LED Sports Lighting RFP for M&T Bank Stadium

**Addendum No. 1 -
12/12/18
Partial RFP**

Typical Luminaire Wiring Diagram

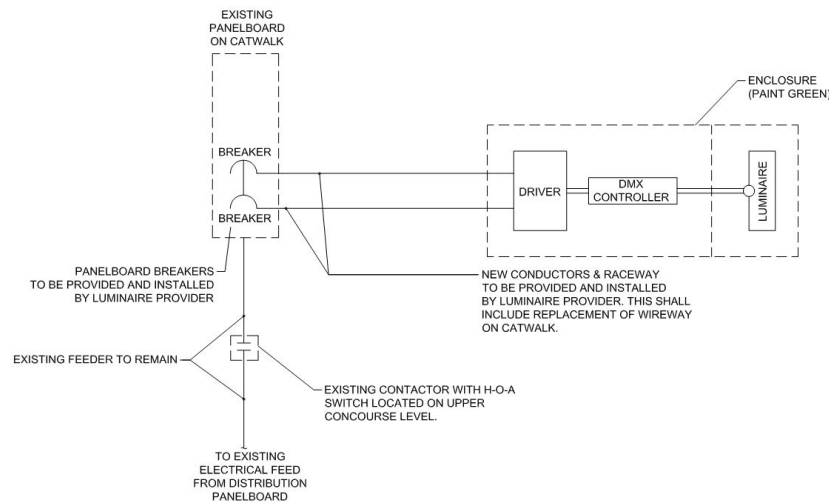
In addition, the new Sports Lighting Control system shall have a DMX loss detection kit and UL924 emergency bypass detection kit for the emergency powered luminaires and data bus. Refer to 'Typical Luminaire Wiring Diagram' below for more information. **The existing control to the contactors shall interface with the new sports lighting control system and the existing Microlite system.**
